**RESPONSES OF WINDHAM SOLAR, LLC
TO
CONNECTICUT SITING COUNCIL INTERROGATORIES - SET ONE**

On December 30th, 2020, the Connecticut Siting Council (“Council”) issued Interrogatories, Set One to Windham Solar, LLC (“Petitioner” or “Windham”), relating to Petition No. 1222A. The Petitioner provides the following responses.

Exhibit F
Photo Exhibits

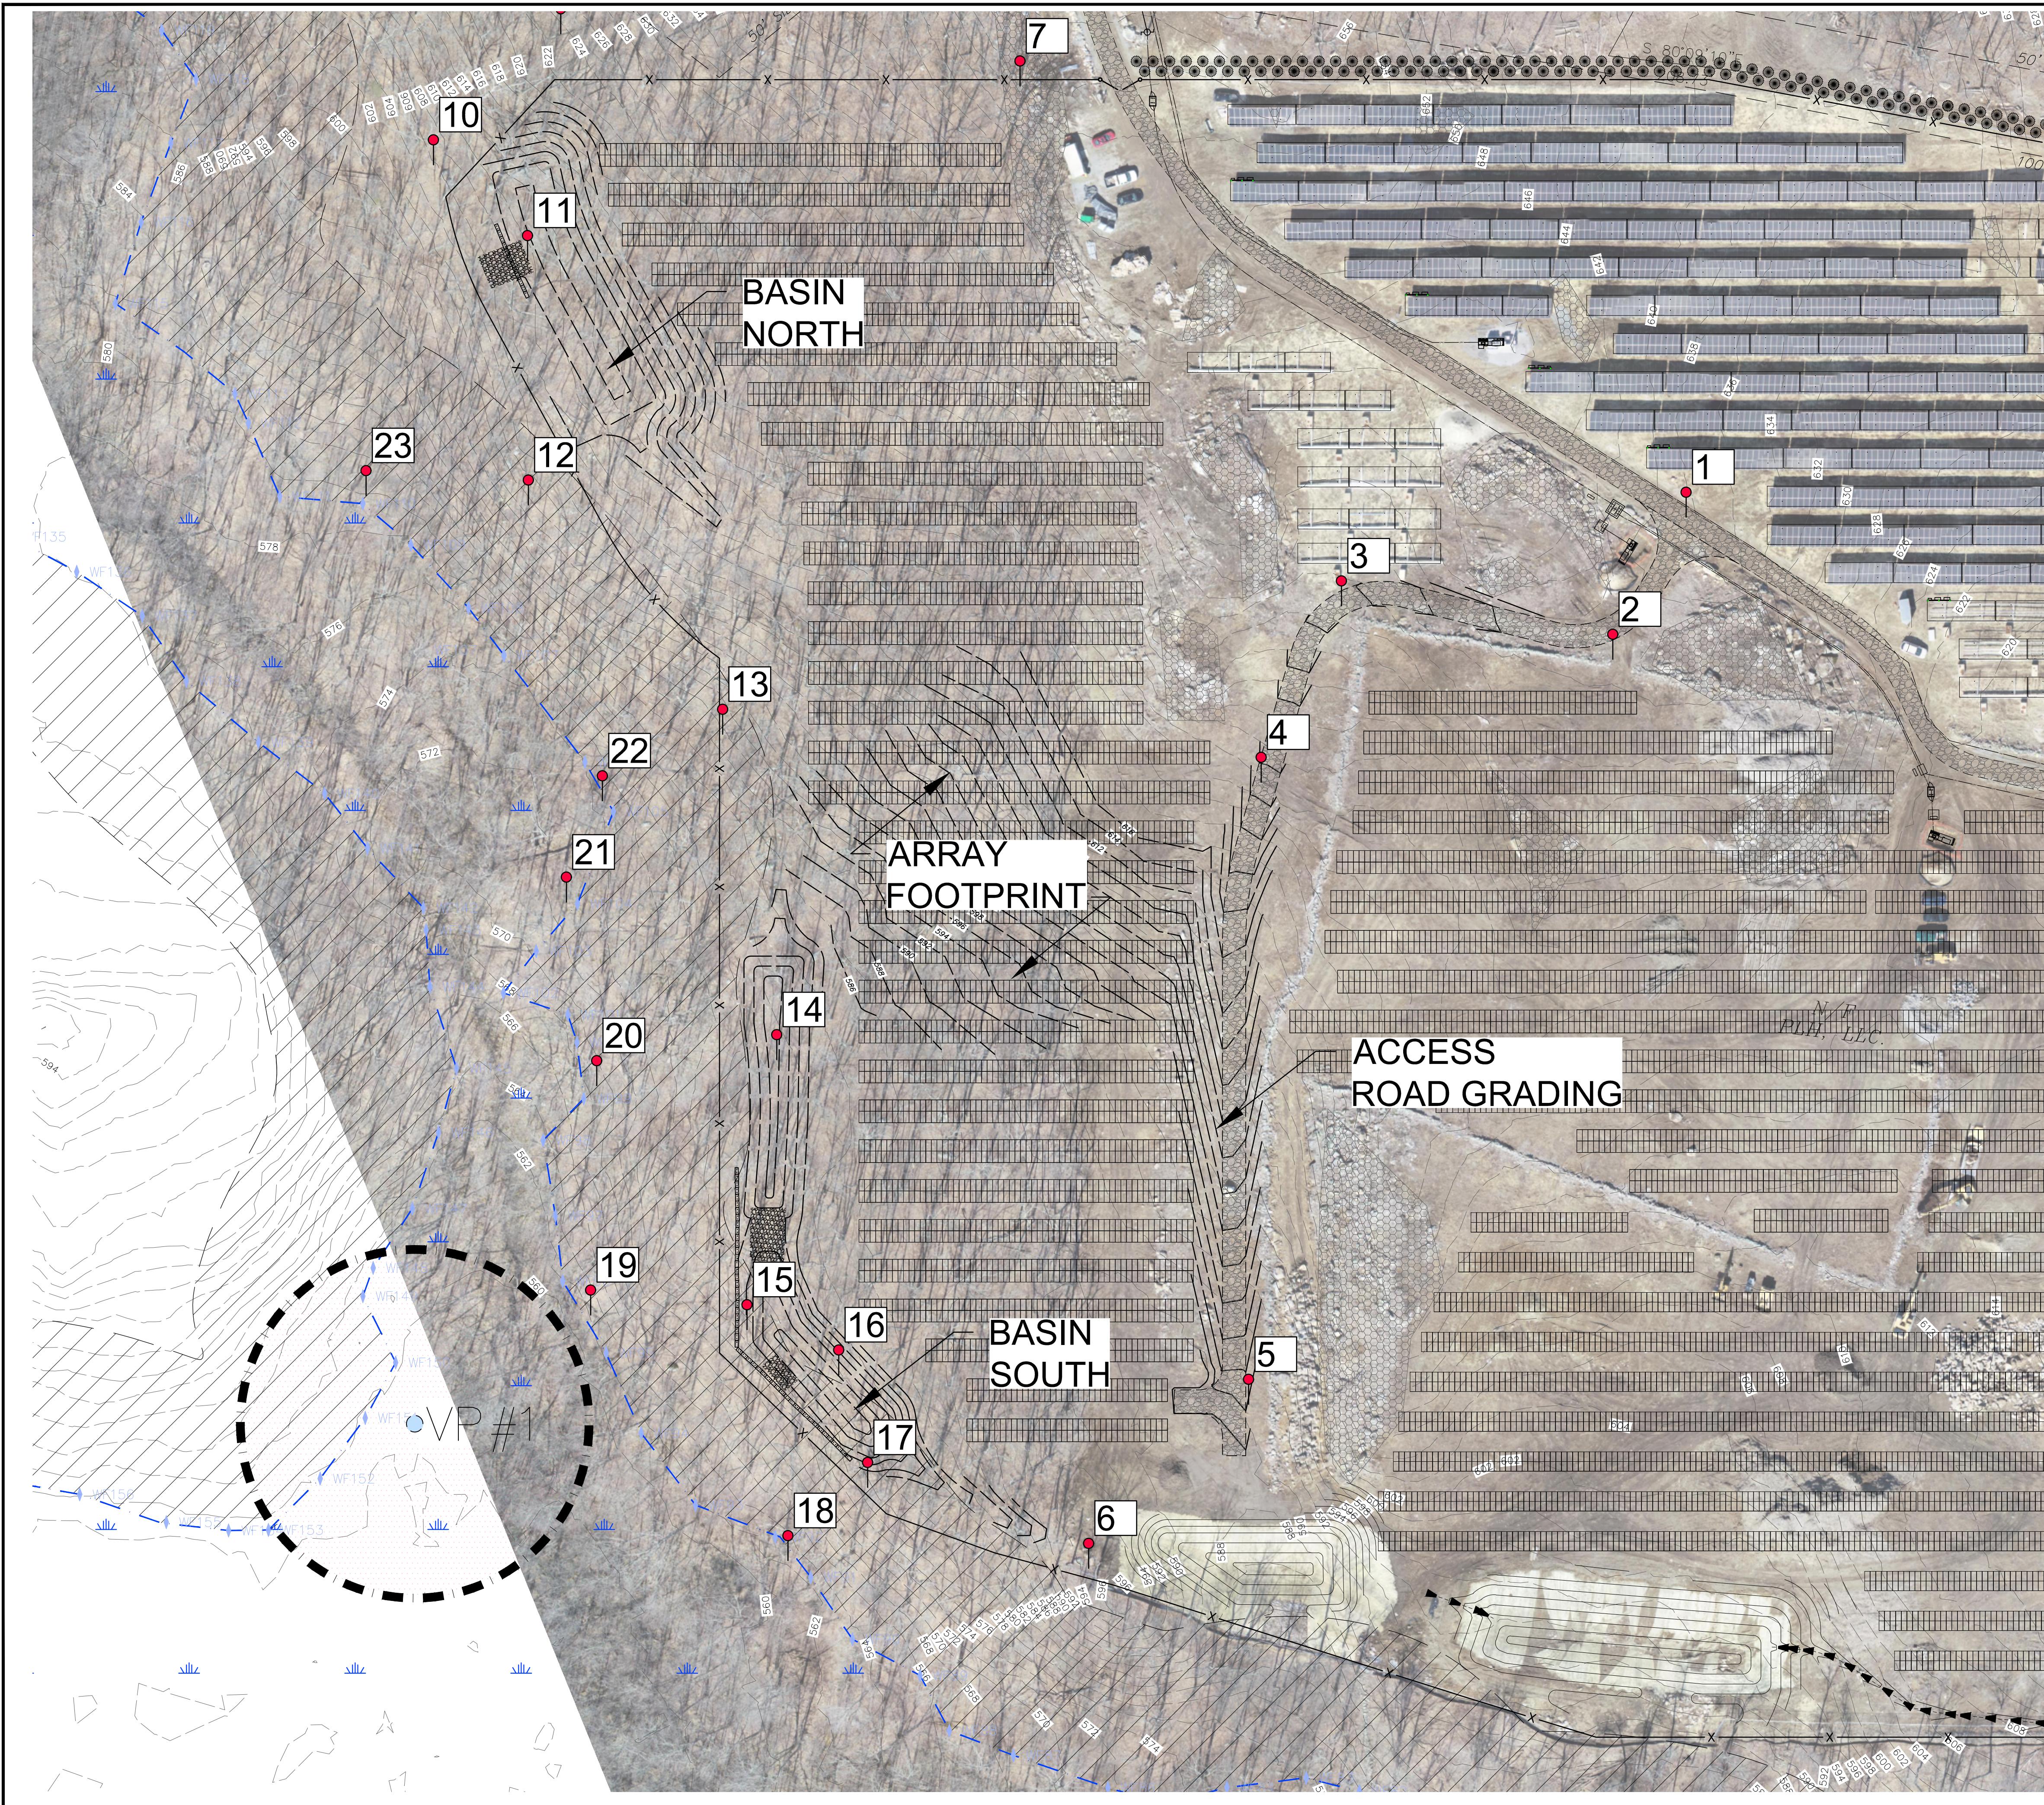
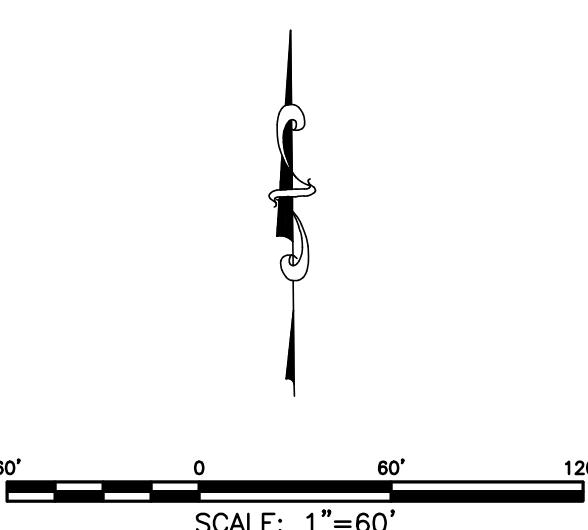
34. Please submit photographic site documentation with notations linked to the site plans or a detailed aerial image that identify locations of site-specific and representative site features for the Future Projects area. The submission should include photographs of the site from public road(s) or publicly accessible area(s) as well as Site-specific locations depicting site features including, but not necessarily limited to, the following locations as applicable:

- a) Will the site be graded? If so, in what areas?

Attached as (***Exhibit F – Photo Exhibits***) is a file that represents current site photos, and areas around the future development projects.

Grading areas are represented in (***Exhibit F – Photo Exhibits***). These grading areas are also associated with the approved SWPCP. Only the basins in the future project areas will require mass grading. Cut material from the basins will remain on site.

Slopes in the Future Project location average 6% to 12%, a fill area is represented in Exhibit F to balance earthwork material on site and improve slopes for the solar racking installation.
